81 Riverside St.
Building Addition
Harper Hotels

Amended Site Plan Submittal, Holiday Inn-West, 81 Riverside Street
(CBL#266A002) (ID#2003-0195)

Response to Comments, Holiday Inn-West, 81 Riverside Street
(CBL#266A002) (ID#2003-0195)

LIGHTOLIER/GENTLYTE		36 Main St. Gorham, ME	
Holiday Inn - Parking			
For: Atlantic Coast Electric		DRW'G. # 2	
SCALE: None		DATE: 1/22/04

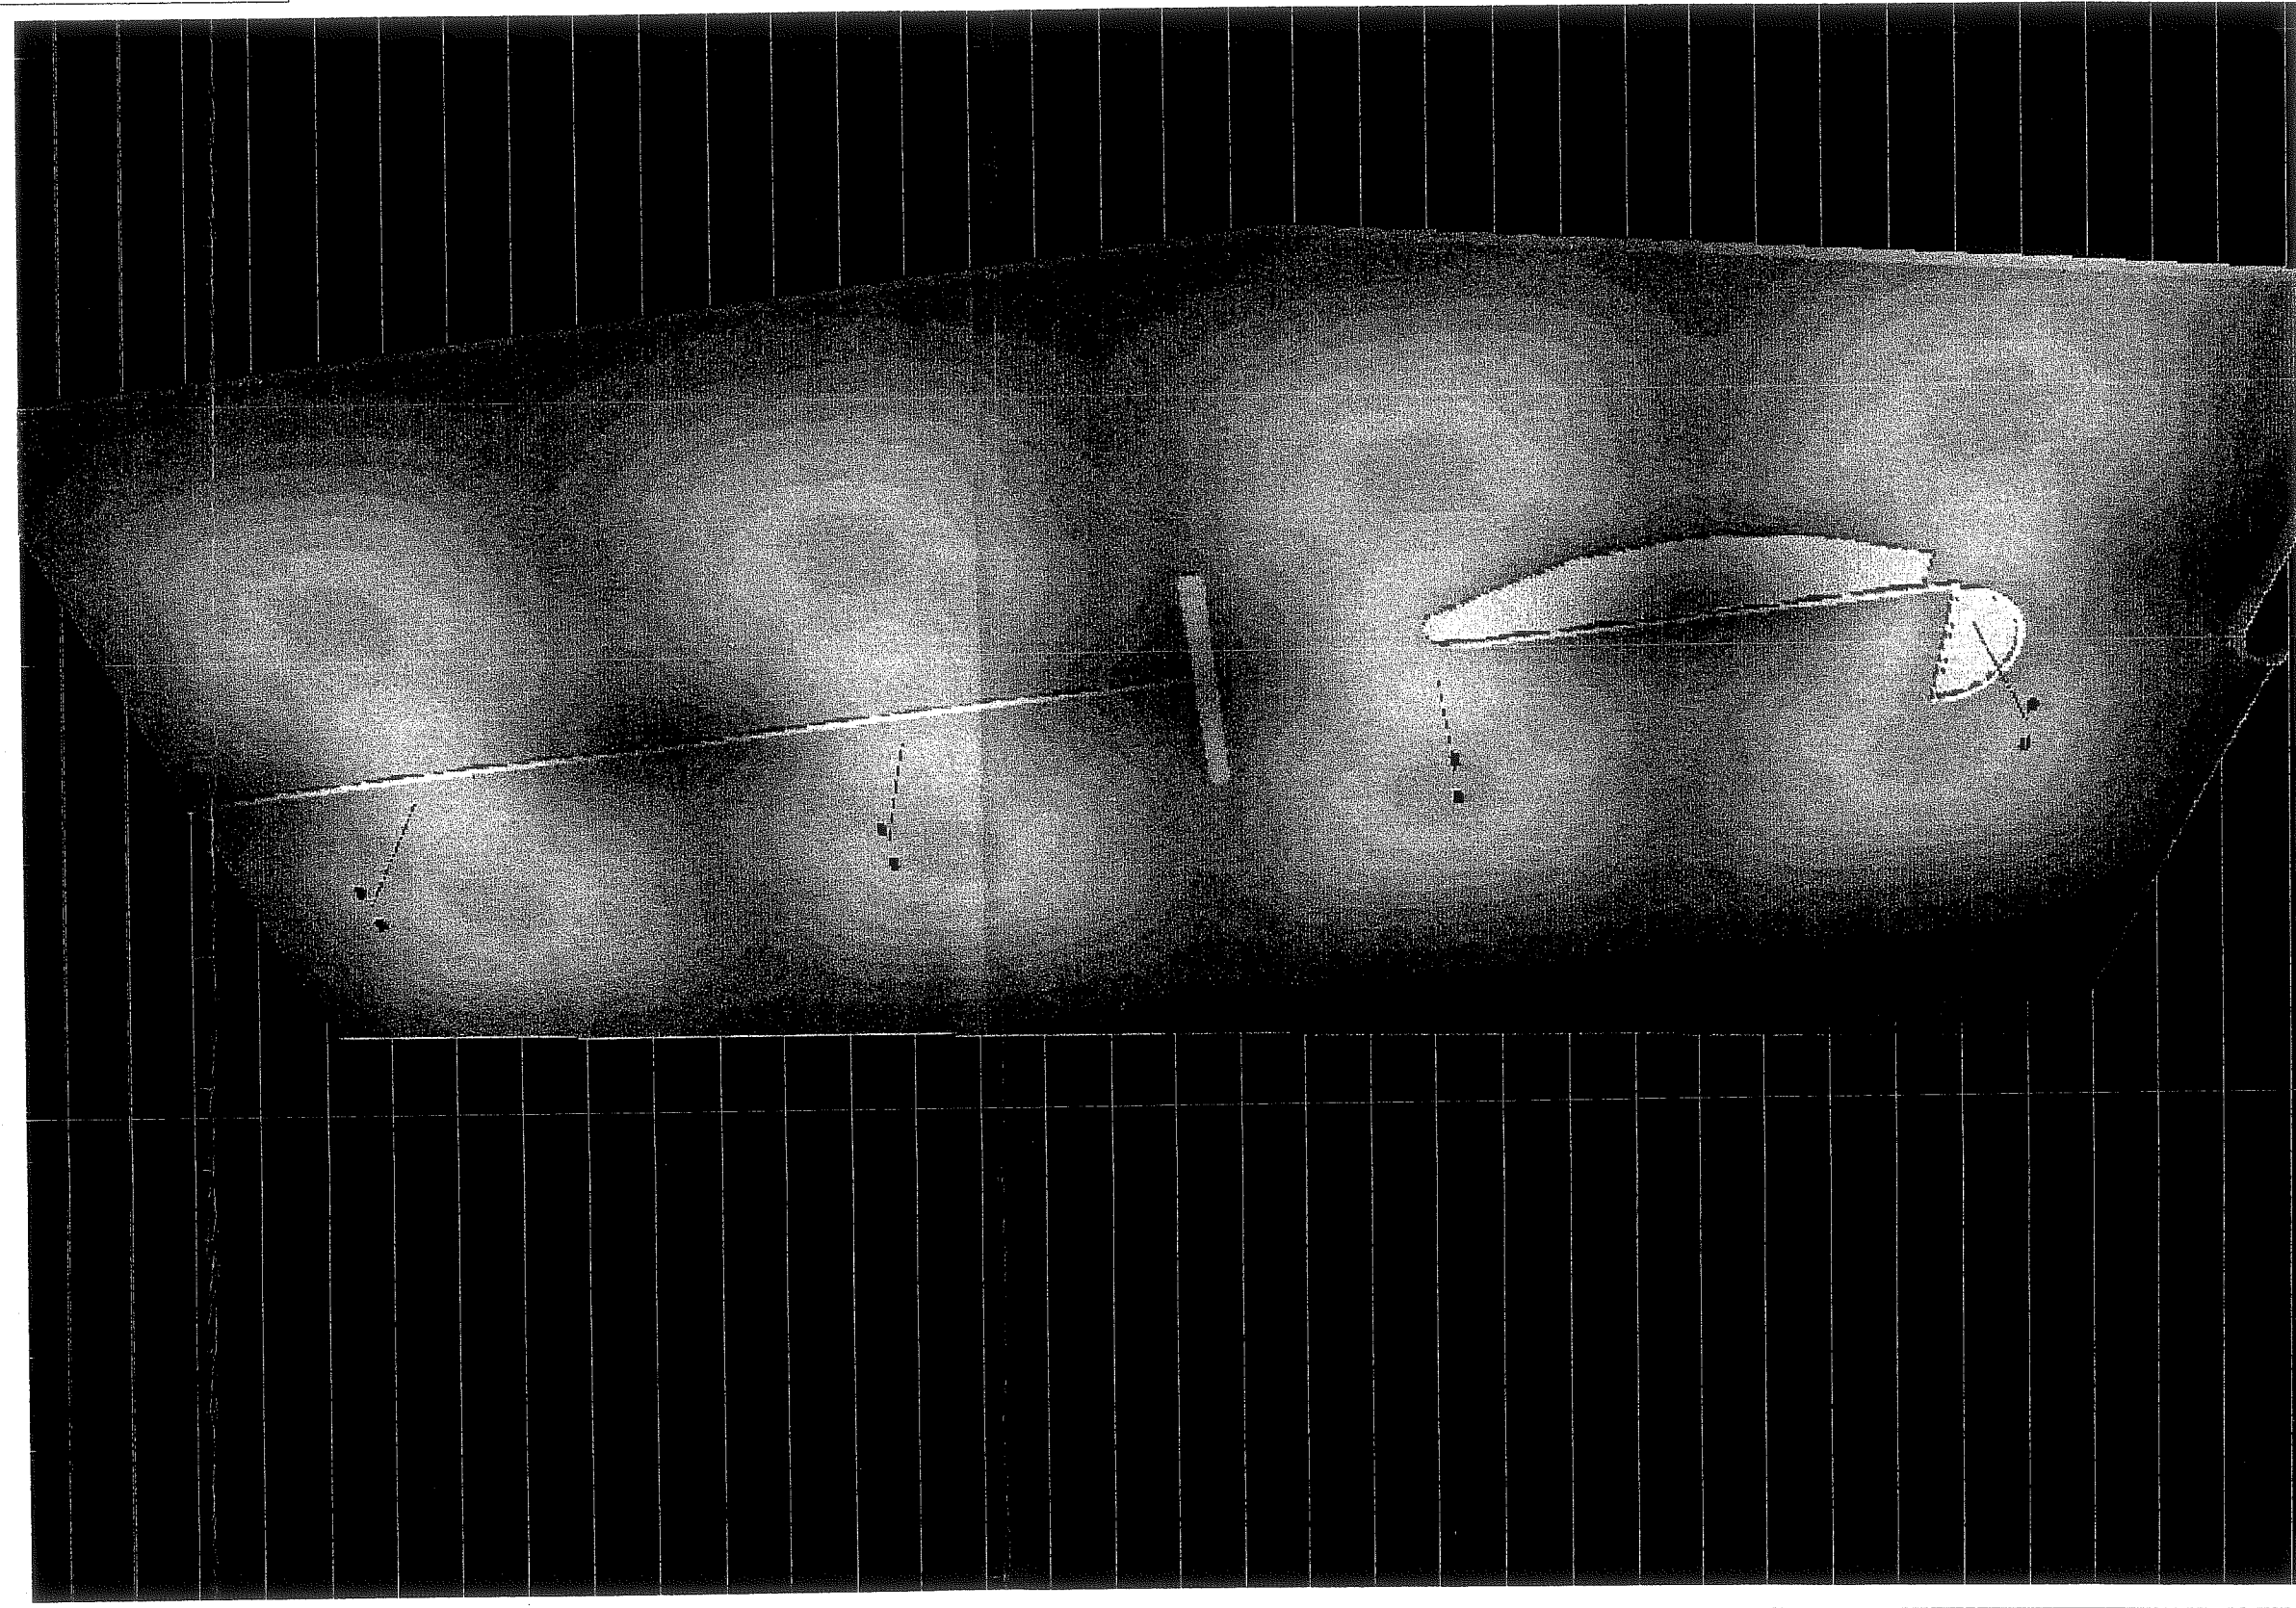
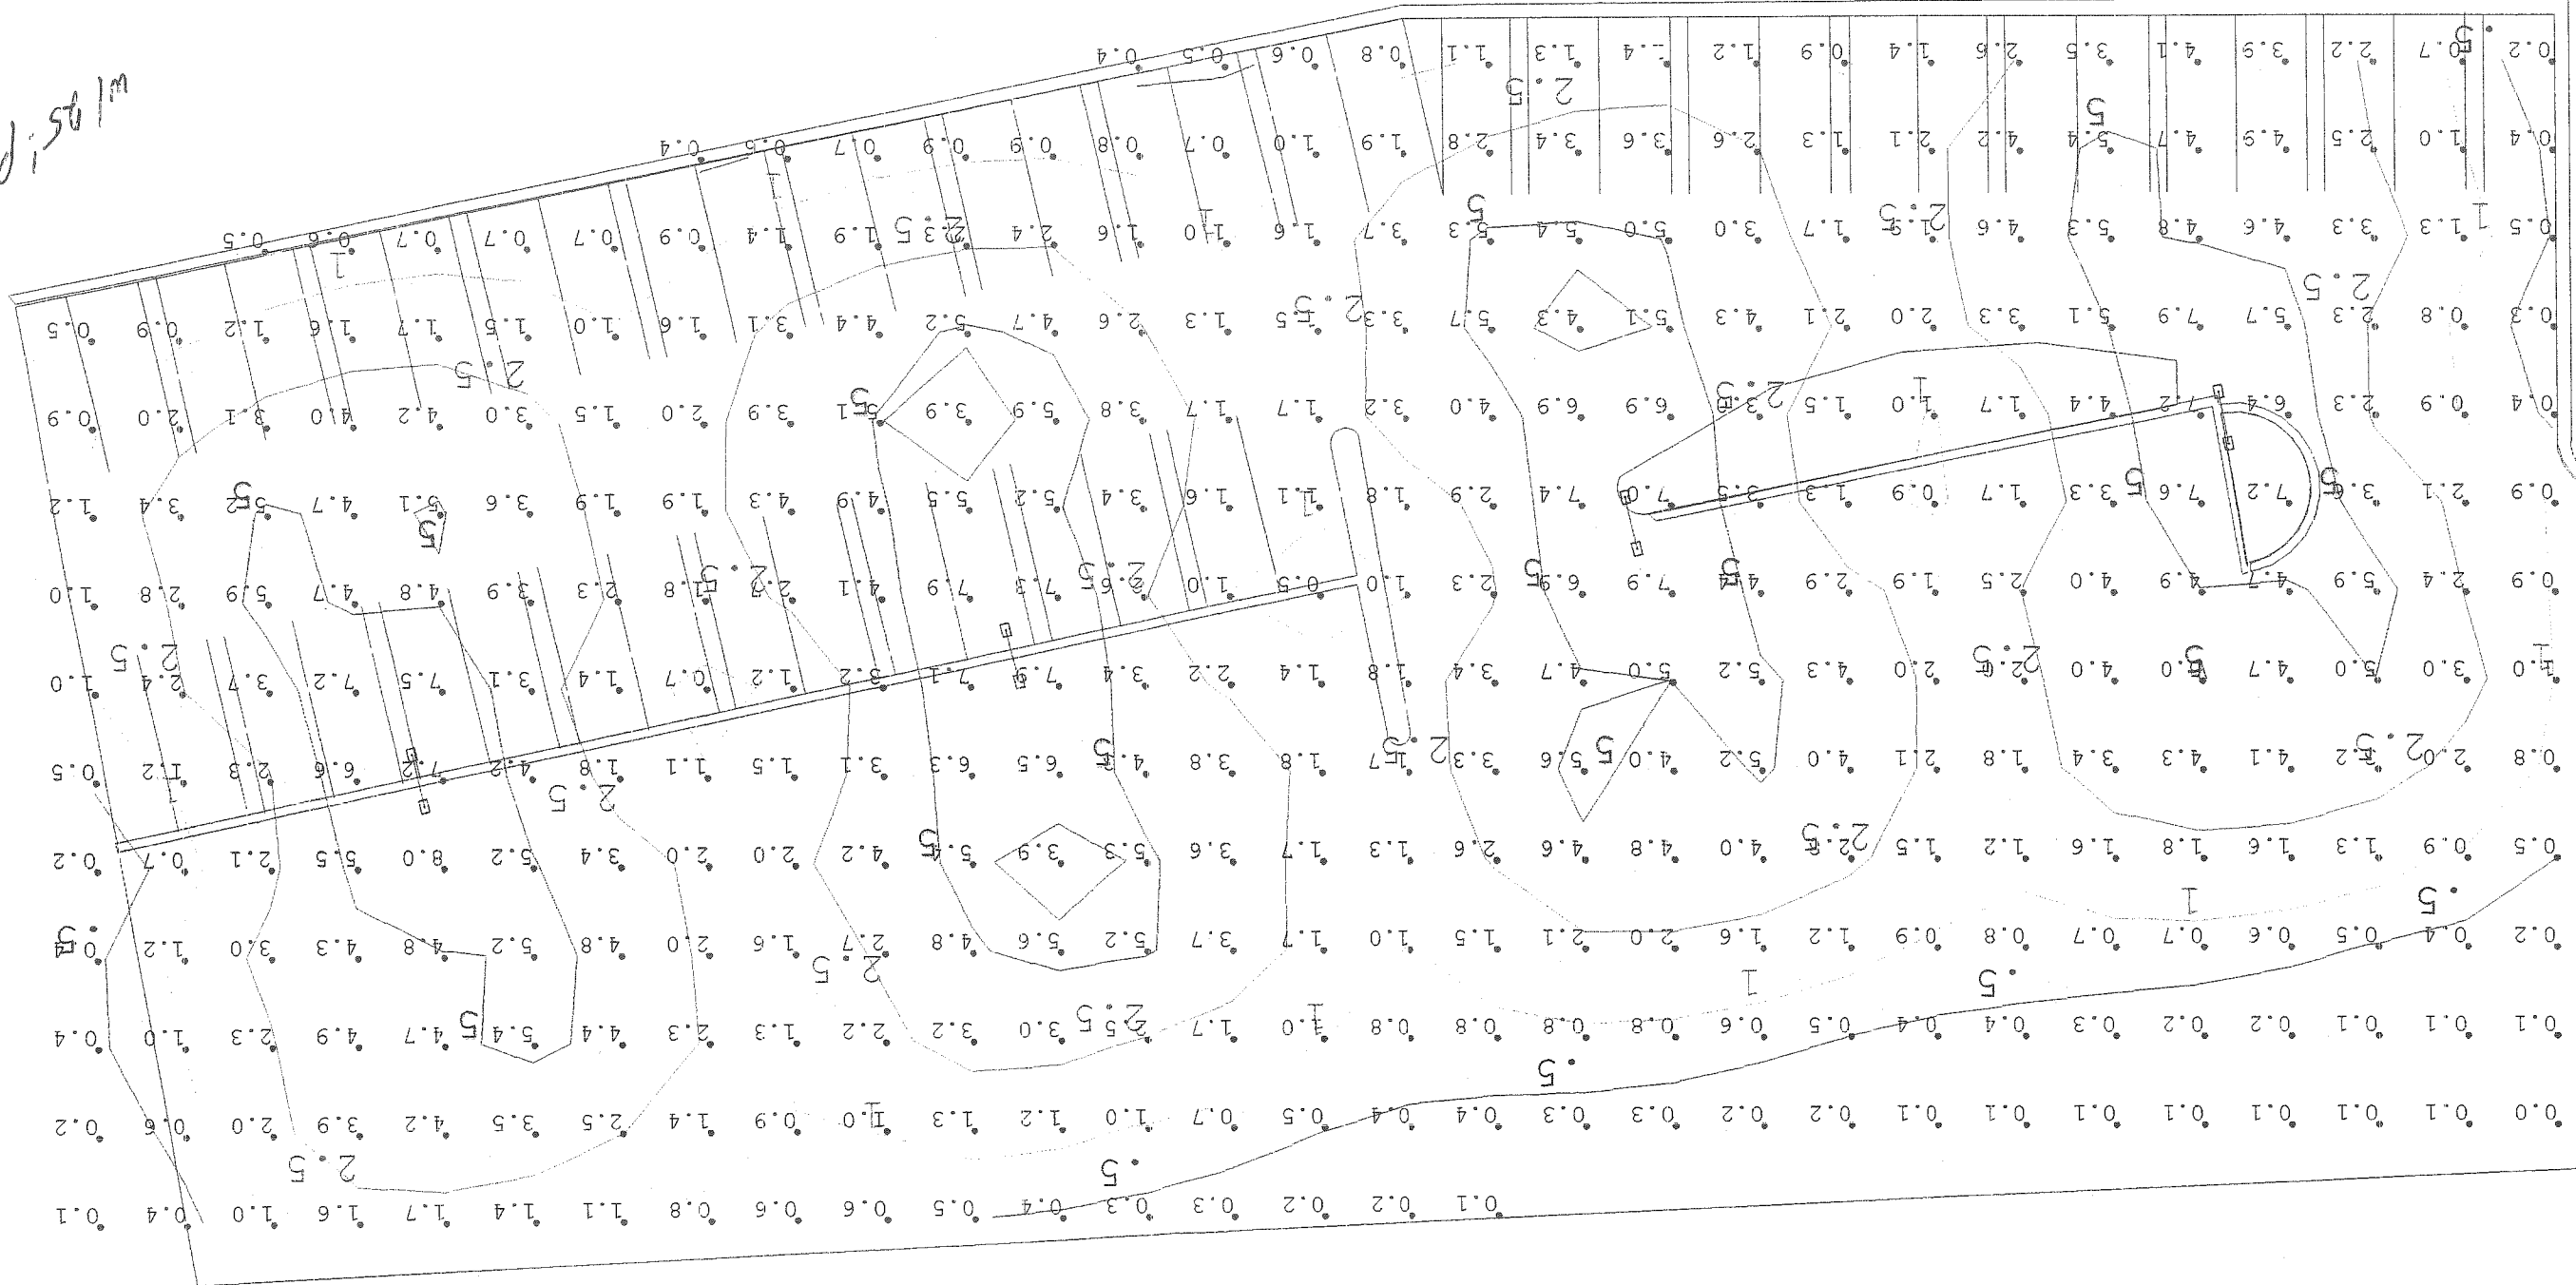
- a. Lighting: Are there any additional lighting proposed? If so, please add pole locations to the plan and submit photometric plans.*

There are four additional light poles that are being proposed for this project. The poles will be installed along the common line of the existing parking area and the proposed parking area. Specific lighting details have been provided by the applicant to show the types of lighting fixtures and the proposed photometrics of the lights in the immediate area.
